Review of Ofgem's RIIO-ET3 Draft Determination on Opex and Risk & Contingency

Prepared for Scottish Power
Transmission

26 August 2025

Figure 3.1: TOs' CAI and Capex data over 2014-2024

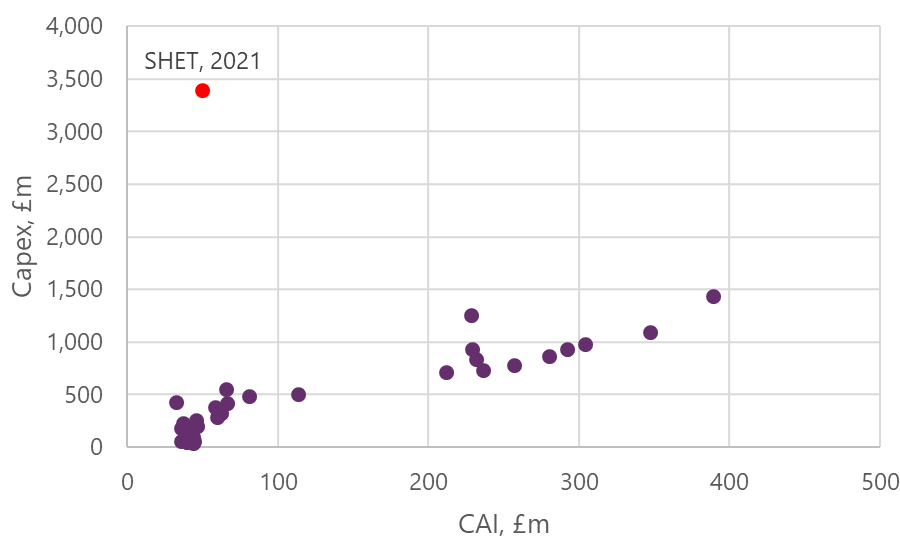
Figure 3.1 below shows a scatter plot comparing the outturn CAI and capex data of the TOs between 2014 and 2024. While in general, the data shows an upward trend between TOs' CAI and capex, the capex data of SHET in 2021 is a clear outlier: SHET's capex in 2021 is 1,732 per cent higher than the TO's average capex for the remaining years in the sample (i.e. 2014-2020 and 2022-2024). Similarly, as shown in Figure 3.2, SHET's totex in 2021 is 1,032 per cent higher than the company's average totex in the remaining years, thus suggesting the TO is an outlier.

Ofgem also notes itself that SHET's data in 2021 is an outlier. Ofgem has relied on an econometric model that regresses TOs' total FTE on total capex, to construct baseline FTEs for the TOs.⁵⁶ In its SQ response to SPT, Ofgem notes that it has removed SHET's data in 2021 in its analysis, on the basis this data point is an outlier.⁵⁷

However, whilst Ofgem removed SHET's capex data in 2021 in its FTE regressions, it has not performed the same adjustment to its CAI and BSC regressions.

We have re-run Ofgem's CAI and BSC regression by removing SHET's data in 2021. The regression results in Table 3.2 show that removing this one data point from the sample has a considerable impact on the regression results:

Figure 3.3: Difference between Modelled CAI Costs and Submitted CAI Costs as a Percentage of Submitted CAI Costs

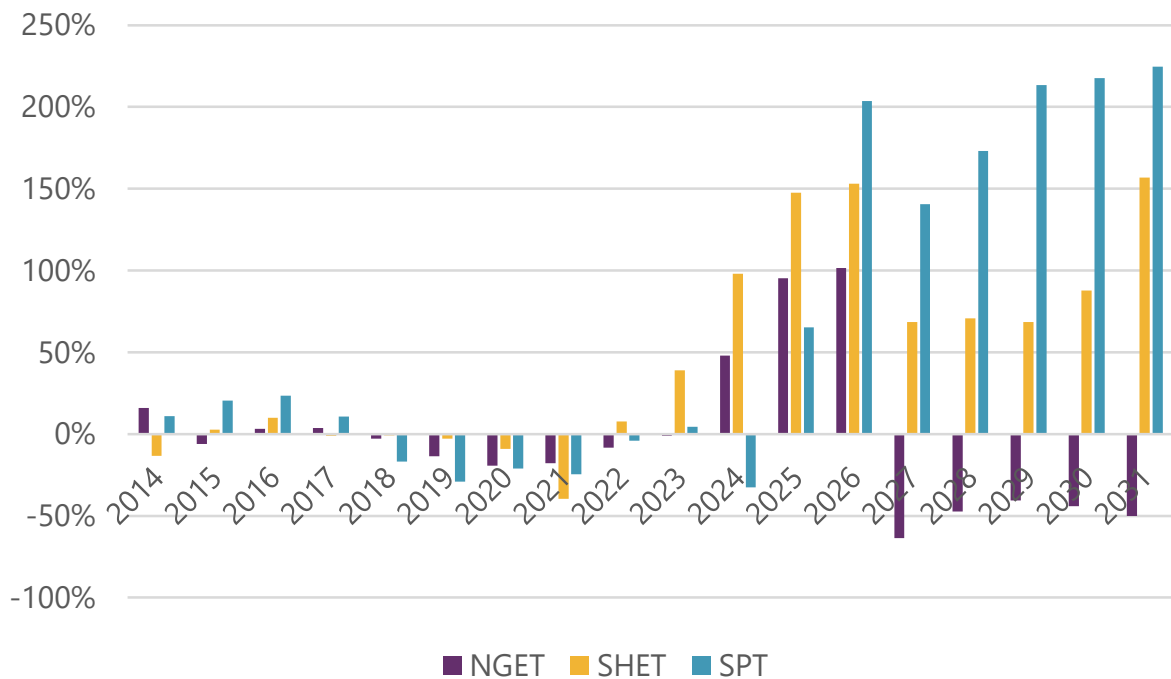
Figure 3.3 below shows the percentage difference between Ofgem's modelled CAI costs and companies' submitted CAI costs (i.e., the annual efficiency gaps of each company, as estimated by Ofgem's model). It shows there are significant differences in companies' efficiency gaps between the historical period that informs the regression (2014-2024) and the forecast period (2025-2031):

- On average over the historical period, the average efficiency gaps for the three companies are 0 per cent for NGET, 8 per cent for SHET and -5 per cent for SPT. These relatively small gaps reflect the high model fit of the model;
- However, the efficiency gap becomes materially wider in the forecast period, up to 225 per cent for SPT in 2031, meaning the company's submitted cost is 3.25 times higher than the modelled cost. By contrast, the forecast modelling suggests NGET's efficiency gap is negative, at -49 per cent *on average* over this period, suggesting its costs are half the "efficient" level predicted by the regression.

- The considerable differences between companies' submitted and modelled CAI costs start to emerge even in the historical period (with the maximum efficiency gap being 98 per cent for SHET in 2024, meaning Ofgem's model suggests the company's submitted cost is almost 2 times its efficient, modelled cost).

The large differences in efficiency scores shown in Figure 3.3, both across time and companies, predicted by Ofgem's CAI model cannot credibly be ascribed to genuine differences in the efficiency of the TOs' operations. It is far more likely that the model is in fact performing poorly in its ability to control for the wide differences between the scale of TOs' operations (see Section 3.2.5) and changes in the cost pressures they face over time (see Section 3.2.6).

Figure 3.4: Difference between Modelled BSC Costs and Submitted BSC Costs as a Percentage of Submitted BSC Costs

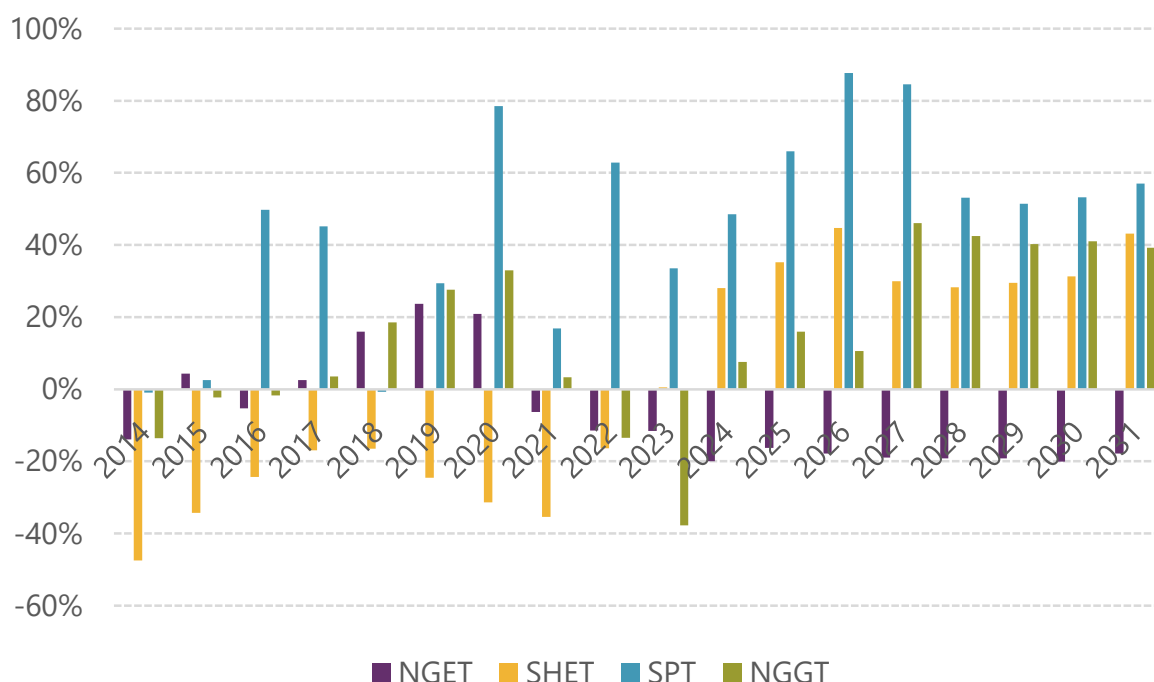
For the BSC model, the failure of the RESET test means that the specification of the BSC model is probably incorrect, as noted above in Section 3.2.3. As a result, the modelled cost estimates and the statistical inference drawn from the model are unreliable. Moreover, as Figure 3.4 shows, we see similarly wide variation in the efficiency gaps implied by Ofgem's regression modelling. Over the forecast period, the model suggests SPT's efficiency gap in BSCs could be up to 88 per cent (i.e., the company's submitted cost is 1.88 times of its modelled, efficient level), whereas NGET's submitted costs are on average 19 per cent below the modelled, efficient level.

Rather than genuine differences in efficiency, the BSC efficiency gaps implied by Figure 3.4 are, as for CAI, are far more likely to be driven by model mis-specification and their inability to control for the wide differences between the scale of TOs' operations (see Section 3.2.5) and the cost pressures TOs face over time (see Section 3.2.6).

Figure 3.5: Yearly BSC to FTE Ratio of SPT, 2014 to 2026

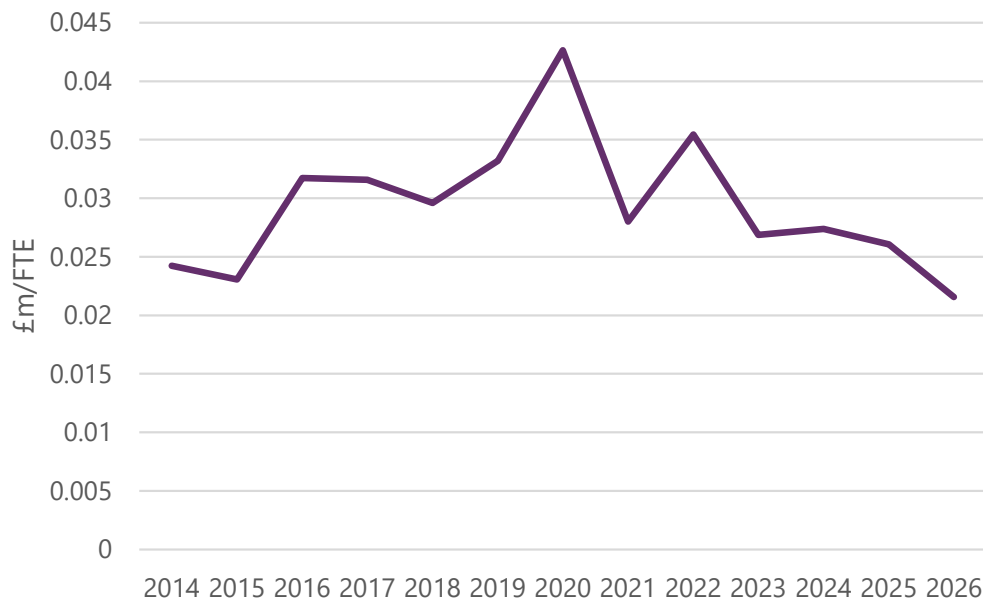
The significant differences in the modelled BSC when using different reference years are primarily due to the volatility in TO's BSC to FTE ratio. Figure 3.5 below shows SPT's yearly BSC to FTE ratio between 2014 and 2026. According to the data, SPT's maximum ratio of 0.043 in 2020 is nearly twice the minimum ratio of 0.022 observed in 2026.

Ofgem's selection of 2026 as the reference year has therefore set SPT's BSC to FTE ratio over RIIO-ET3 at the minimum level observed in the historical data. This approach therefore ignores the variations in TOs' annual BSC to FTE ratio for reasons beyond efficiency (e.g., the share of contractors as discussed above).

In addition, Ofgem's trend analysis extrapolates from a forecast BSC to FTEs ratio in a future year (2026), so it likely to be highly sensitive to the accuracy of the TO's annual forecasts. Given the considerable uncertainty facing TOs, it is unlikely that they can predict with precision how FTEs and BSCs will change from year-to-year, as costs may be incurred slightly earlier or later than expected. Therefore, Ofgem's approach is likely to generate misleading predictions.

Figure 4.1: Bridge from SPT's RIIO-ET3 Business Plan NOCs Proposals to Ofgem's Draft Determination Allowance

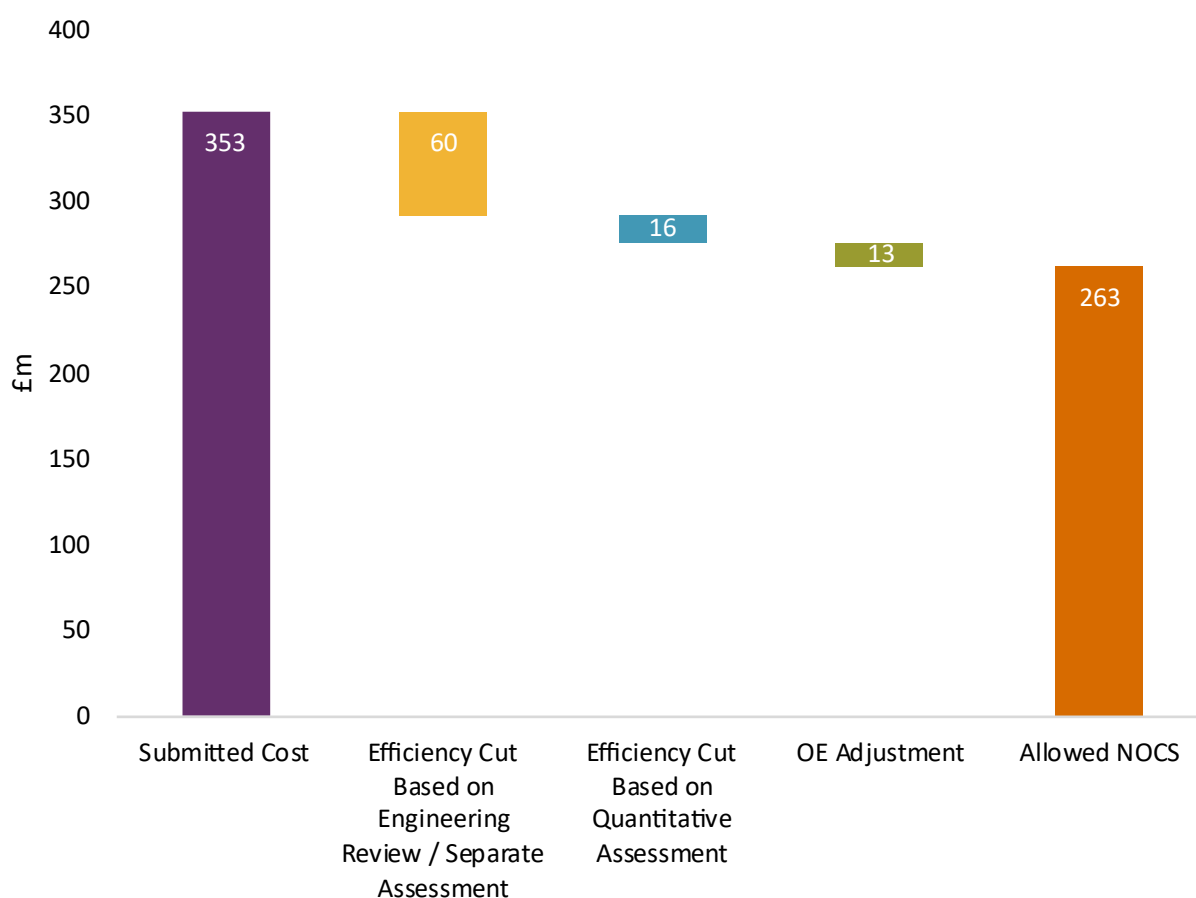
SPT's business plan submitted a request for funding of £353m for NOCs for the RIIO-ET3 period, of which Ofgem allowed £263m (75 per cent). Figure 4.1 below shows the breakdown of SPT's disallowed NOCs. The largest disallowance is through the engineering review / separate assessment of £60m, made entirely to operational technology costs. Whilst we do not comment in detail on Ofgem's engineering review / separate assessment in this report, it is important that when Ofgem undertakes this review, it comprehensively considers the evidence presented to it by SPT within its Business Plan submission.

(£2.27m), vegetation management (£2.52m), and "NOCs other" costs (£3.02m). Ofgem also makes an Ongoing Efficiency (OE) adjustment – not discussed in this report – of £13.42m to obtain a final NOCs allowance of £263m.

The efficiency adjustments made by Ofgem through quantitative analysis result from application of either Ofgem's unit cost approach or its annual average cost approach, allowing SPT a lower unit cost per unit of activity than SPT forecast in its business plan. The remainder of this section explains the flaws in Ofgem's NOCs assessment approach which affect the efficiency cut applied through its quantitative assessment.

Figure 4.2: SPT Unit Costs for Cost Areas Assessed via Unit Cost Assessment

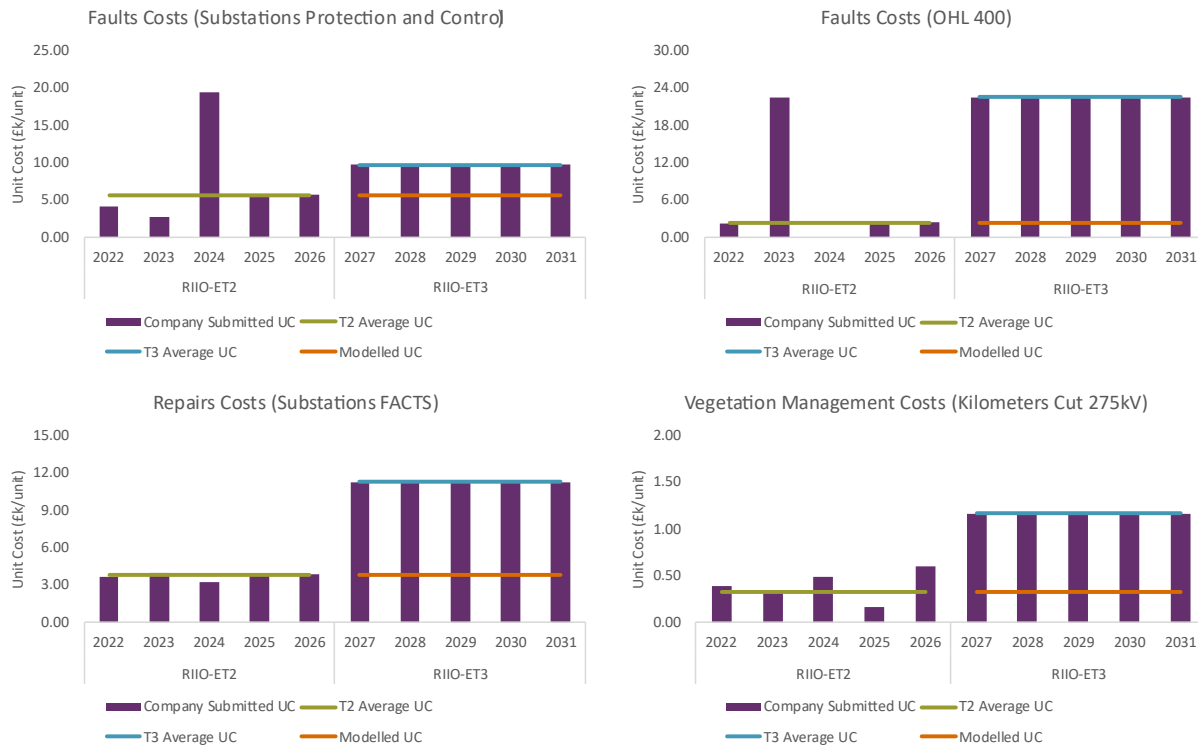
Figure 4.2 below shows four examples of NOCs cost areas for which Ofgem uses the unit cost assessment approach to set allowances, but for which SPTs' unit costs are volatile across RIIO-ET2 and RIIO-ET3.

Figure 4.2 shows that in some cost categories SPT's unit costs are rising very materially between the RIIO-ET2 and RIIO-ET3 control periods, and Ofgem's cost assessment approach makes no attempt to assess whether such changes are reasonable, and instead systematically disallows them. Ofgem's approach adopts this simplistic approach because its materiality thresholds are not met for these cost categories. As a result, Ofgem sets the unit cost for RIIO-ET3 based on the unit cost across the RIIO-ET2 period, relying on the assumption that unit costs can only fall over time (as discussed in Section 4.3.2 above).

In part, this is driven by the arbitrary selection of thresholds, and the way in which Ofgem applies them. In Section 4.3.4 we discuss the materiality thresholds, and in Section 4.3.6 we show the impact on SPTs' allowances of relaxing these thresholds.

Figure 4.3: Comparison of Unit Cost Approach and Annual Average Cost Approach

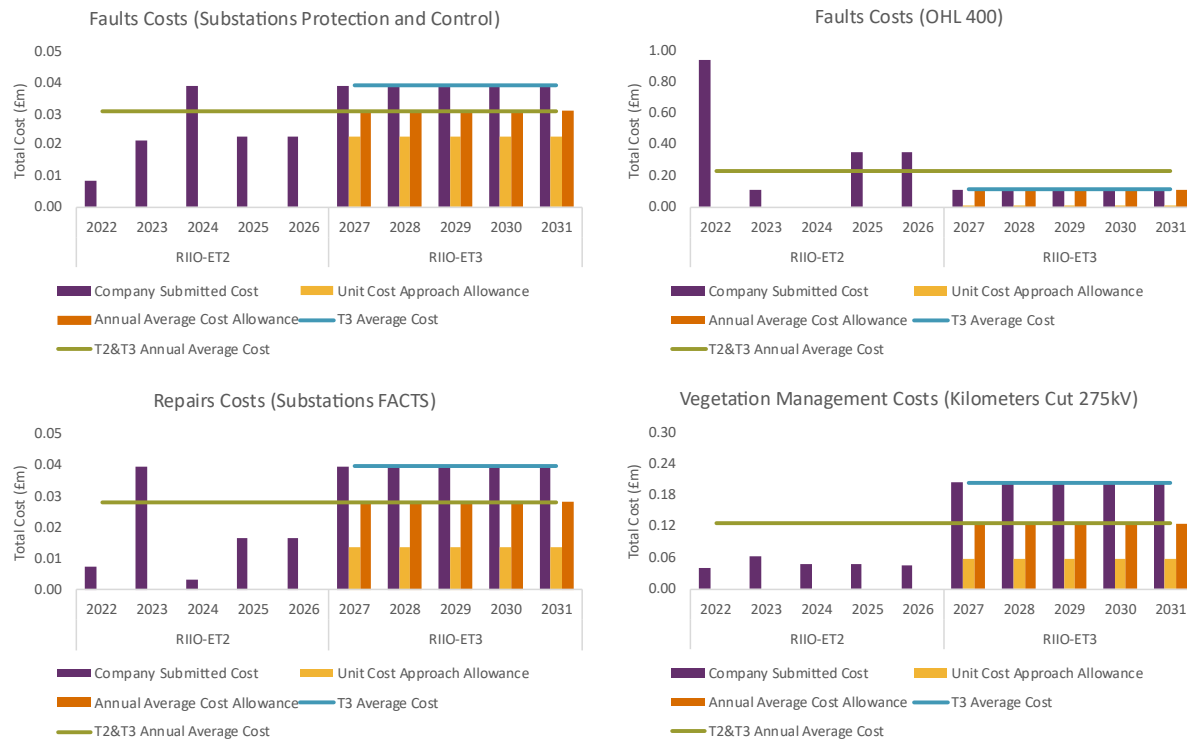
The annual average assessment approach is an improvement on Ofgem's RIIO-ET2 approach, because it removes the bias implied by the simplistic assumption that efficient unit costs can fall but never rise.

However, this approach still uses the RIIO-ET2 unit costs to inform the RIIO-ET3 allowed unit cost, making no attempt to consider whether changes in unit costs are occurring due to exogenous factors. Hence, it may still generate misleading results. For example, Figure 4.3 shows the same four NOCs cost areas as in Figure 4.2. Even if Ofgem switched to the annual average cost approach, while allowances would increase compared to the unit cost approach used by Ofgem, the allowance would still be below SPT's submitted costs for 3 out of the 4 cost areas.

Figure 5.1: The Correlation Between a Project's Direct Costs and its Share of R&C Costs Is Only 7 Per Cent

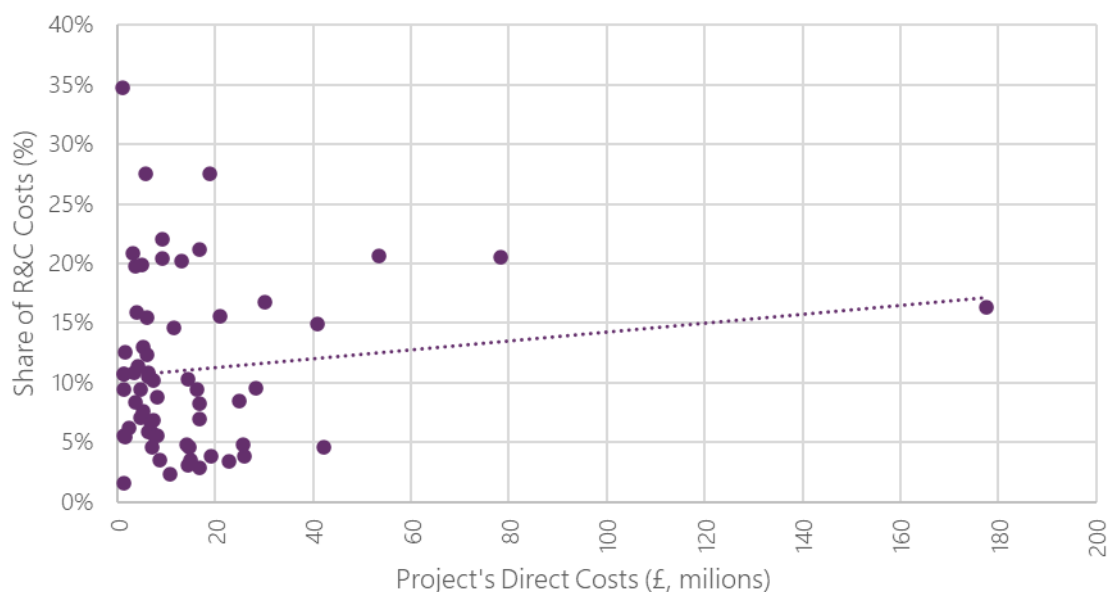
Our analysis, as shown in Figure 5.1, confirms that there is a very weak correlation between the percentage of the R&C costs and project size in SPT's sample, when excluding the outliers (18.7 per cent for load, negative 29.1 per cent for non-load, and 4.4 per cent overall). This analysis shows that there is no basis for applying different treatment to the R&C costs for large and small projects, and introducing an arbitrary threshold seems unsupported.

The effect of this threshold is to disallow a material portion of the TOs' R&C costs. Ofgem acknowledges that setting the threshold at £100,000 would mean that only 7 per cent of projects (by value) would receive the total R&C costs requested in full (subject to the scheme being approved by the engineering assessment).¹³⁴
